Joseph M. Farley Nuclear Plant - Units 1 and 2  
NUREG-0737 Item II.B.3 Post Accident Sampling System

ATTACHMENT  
Alabama Power Company (APCo) Responses to  
NRC Questions/Criteria

FIGURE 2

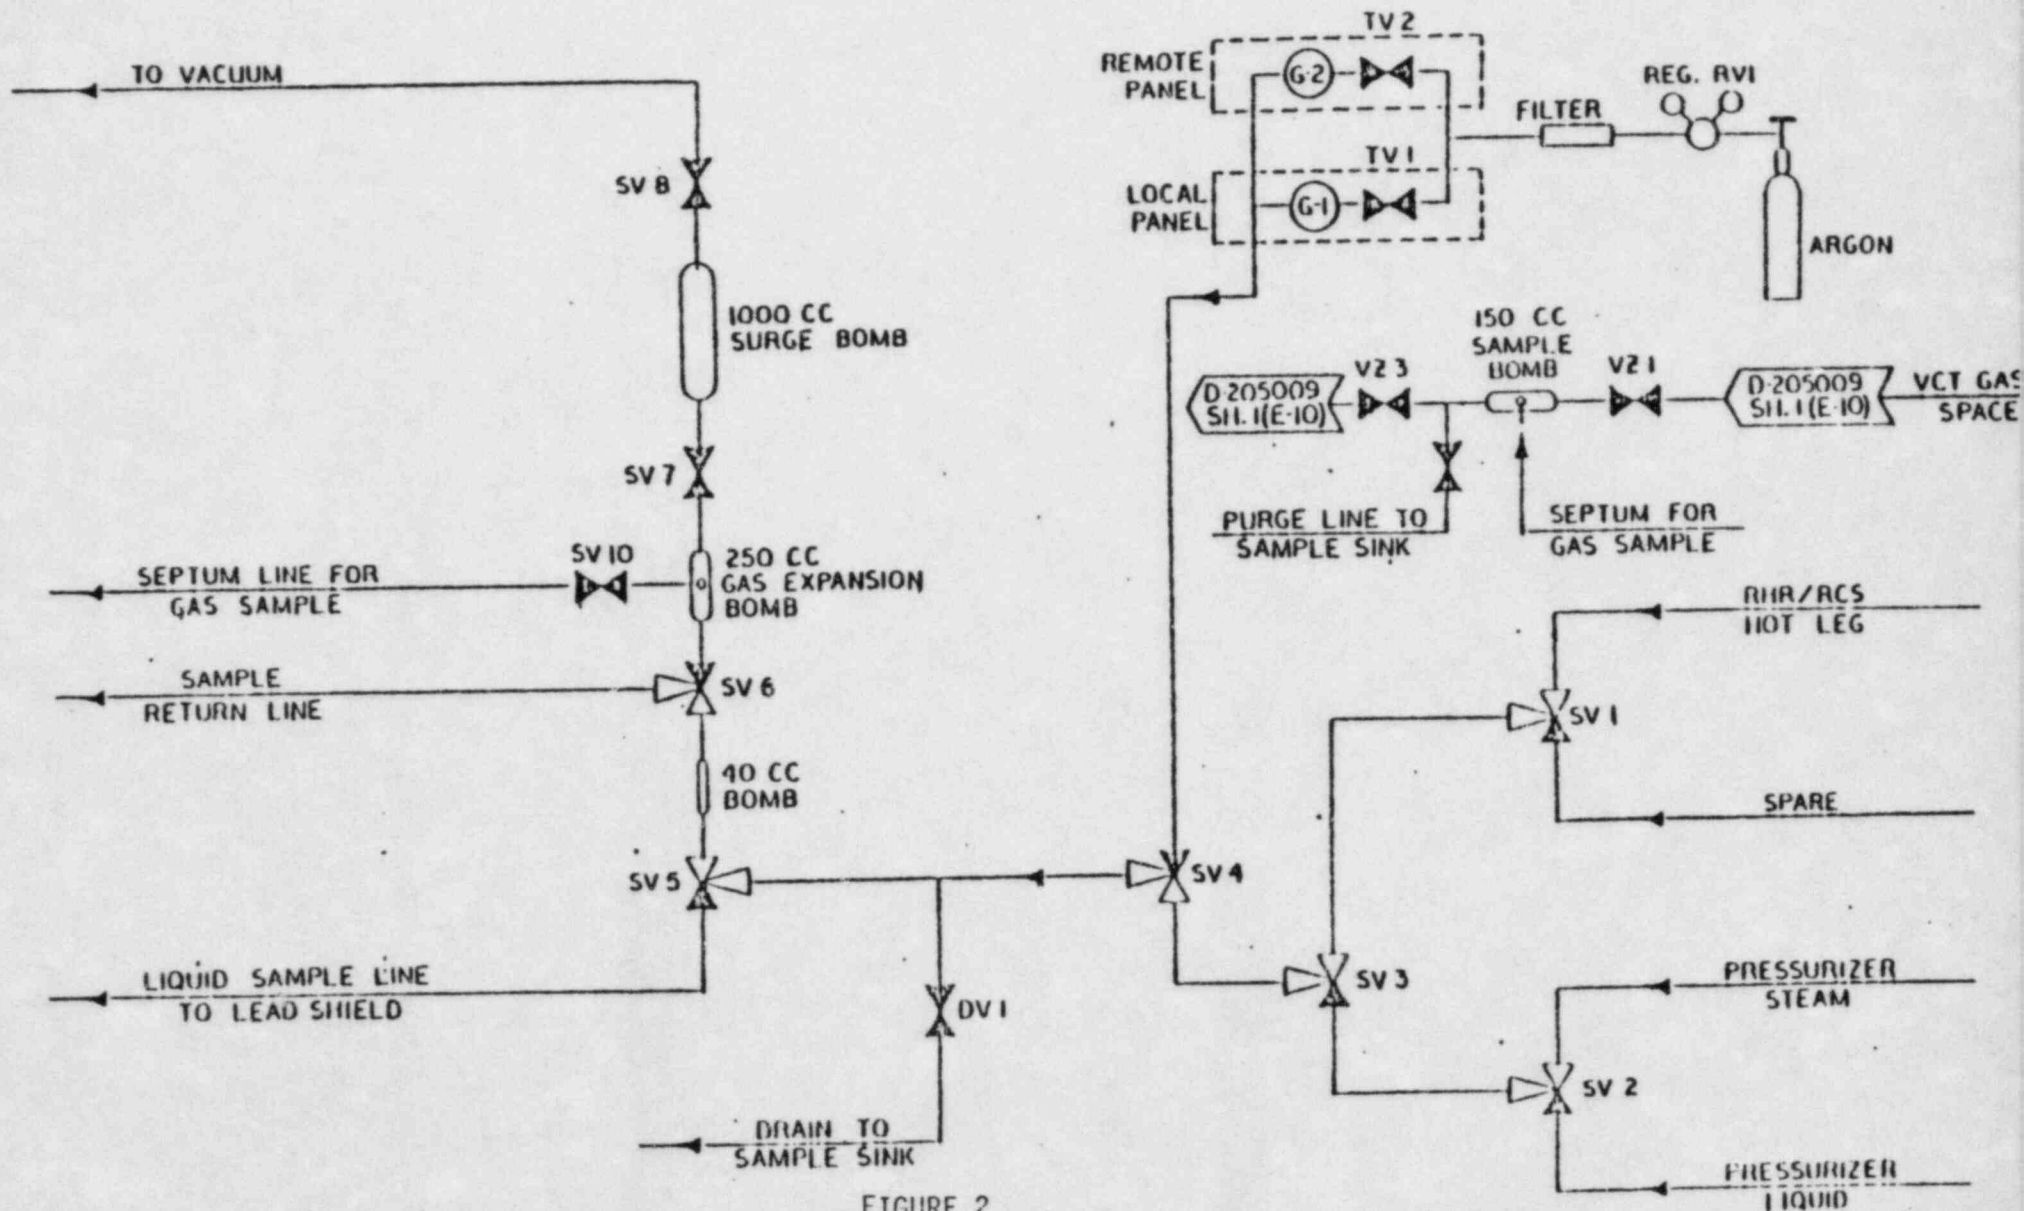
Provide information on sampling system(s) and analytical laboratories locations including a discussion of relative elevations, distances and methods for sample transport. Responses to this item should also include a discussion of sample recirculation, sample handling and analytical times to demonstrate that the three-hour time limit will be met (see (6) below relative to radiation exposure). Also describe provisions for sampling during loss of off-site power (i.e. designate an alternative backup power source, not necessarily the vital (Class 1E) bus, that can be energized in sufficient time to meet the three-hour sampling and analysis time limit).

The Sample Room, Counting Room and Radiochemistry Lab for the Farley Nuclear Plant (FNP) Post Accident Sampling System are located on the 139' elevation of the Auxiliary Building (Figure 1). A pressurized Reactor Coolant Sample (RCS) can be promptly obtained from the remote sample station located on the 139' elevation of the Auxiliary Building. The pressurized sample is circulated through a 40 cc stainless steel sample bomb which purges any resident water and ensures that the resultant sample is representative of the coolant system (Figure 2). The sample is degassed and an aliquot of the gas is drawn off by microsyringe and injected into a gas chromatograph for analysis. The liquid portion of the sample is injected into a 50 cc shielded sample vial located in the sample room (Figure 3). The sample is then transported to the lab for analysis by means of a shielded sample transport cart which has been designed to minimize any radiation exposure.

In case of containment isolation prior to a sample request, approximately 30 minutes will be required to reestablish flow and obtain a representative sample at system pressure (system pressure [2200 psig] provides the driving force for sample flow). If RHR has been initiated, an additional 15 minutes may be necessary due to the reduced system pressure. Sample preparation will then require 30 minutes to one hour, dependent upon the availability of the unaffected Unit's lab. Chemical and isotopic analyses will require approximately 30 minutes.

FIGURE 3

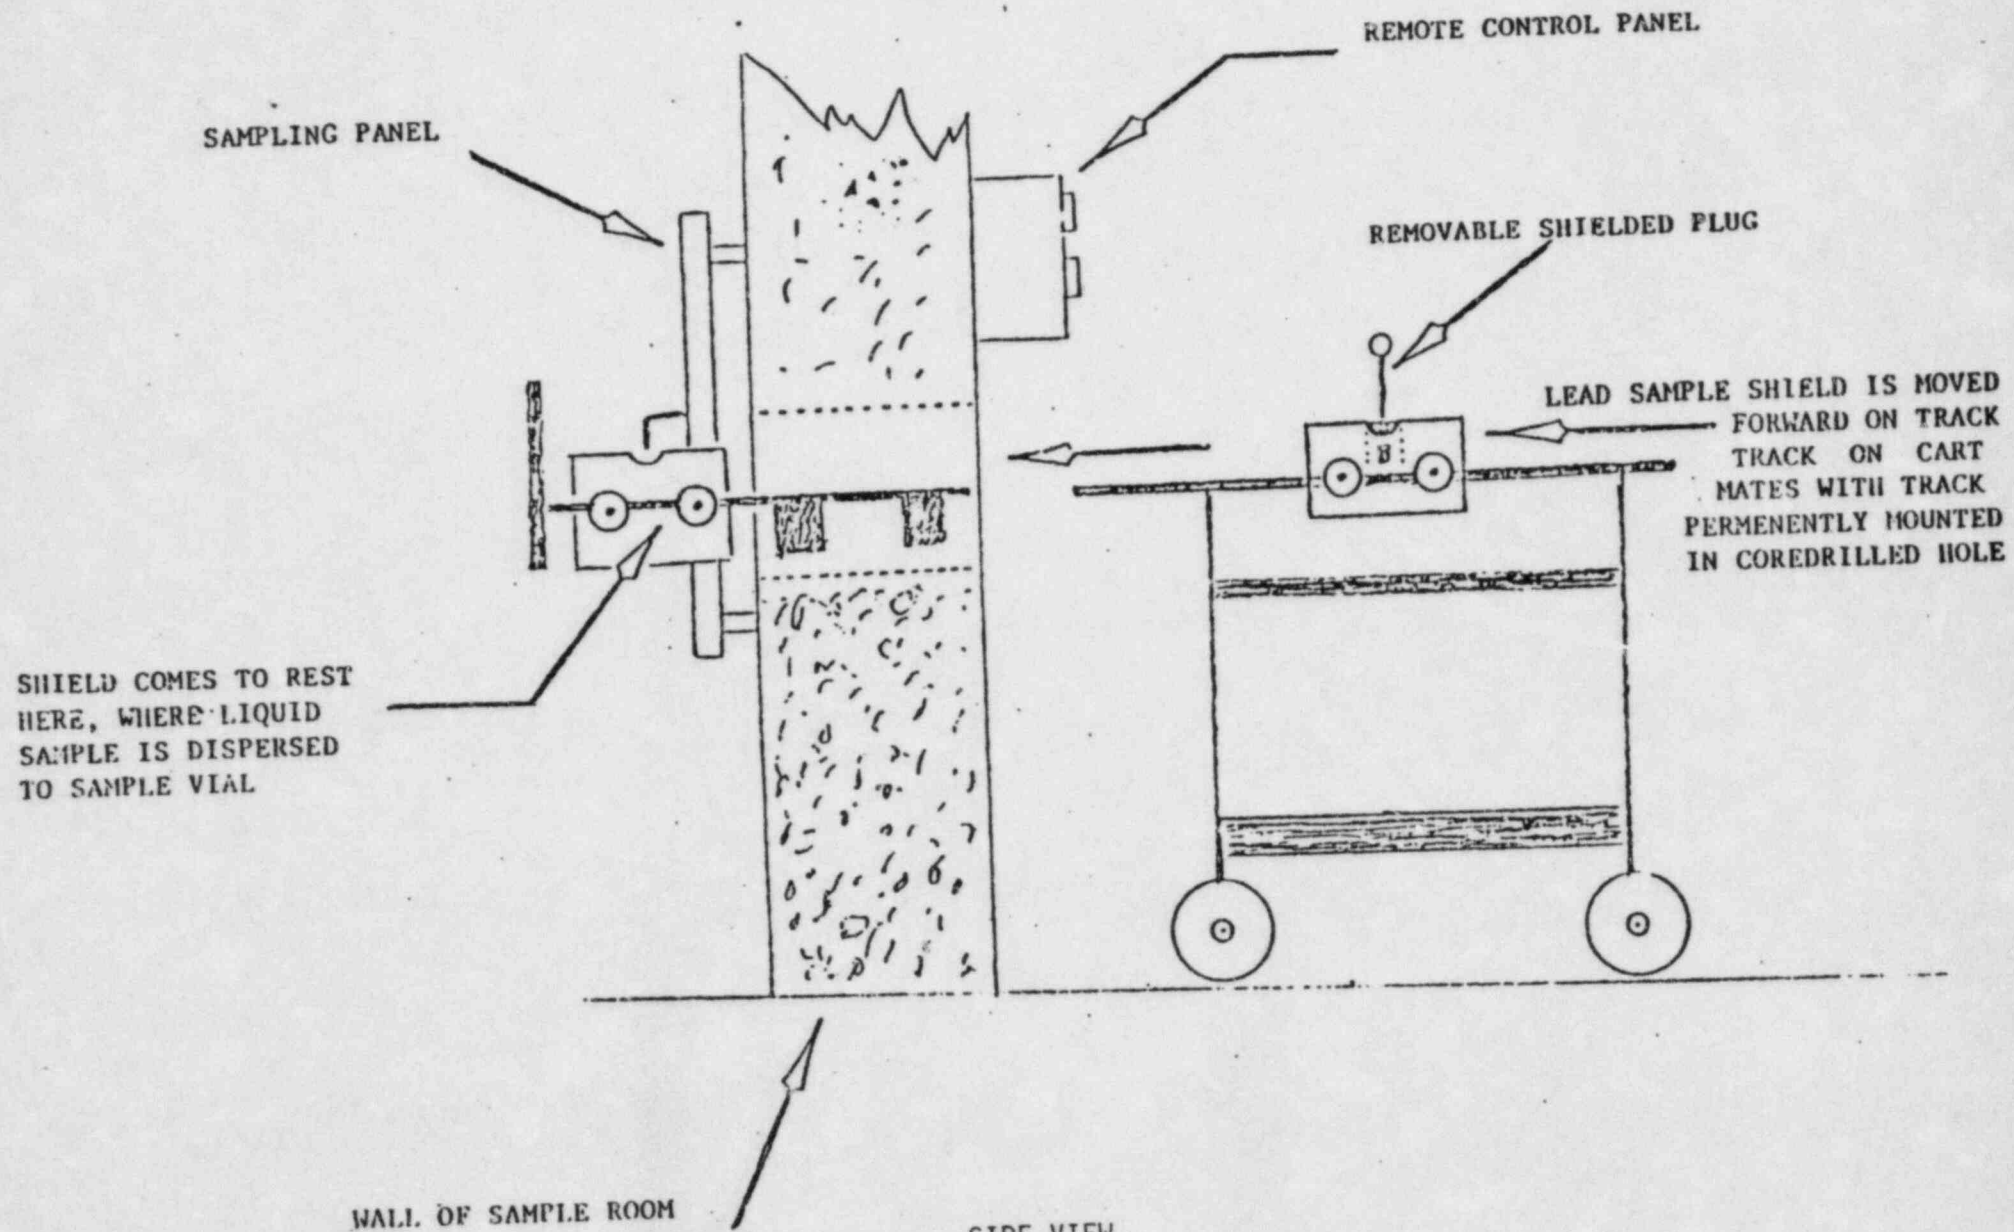
9(a) Provide a discussion of the predicted activity in the samples to be taken and the methods of handling/dilution that will be employed to reduce the activity sufficiently to perform the required analysis. Discuss the range of radionuclide concentration which can be analyzed for, including an assessment of the amount of overlap between post accident and normal sampling capabilities.

9(a) The FNP post accident sampling system is the normal pathway for routine sampling and will accomodate activity levels up to 10 Ci/gm. The shielded sample vial (Figure 3) is not normally used for routine sampling; however, it is available for sampling whenever deemed necessary by Health Physics surveys. Dilution of the samples is accomplished by pipetting one ml of the sample into a beaker of 999 ml of demineralized water and NaOH located behind a lead shield and lead glass window. If necessary, a second dilution may be performed as described above to further reduce the sample activity. The second dilution results in a reduction of  $10^6$  in activity. As the FNP analytical equipment has a range of  $5E-7$  to 10 micro Ci/gm, samples with an activity approaching 10 micro Ci/gm must be diluted as described above before an analysis can be performed.
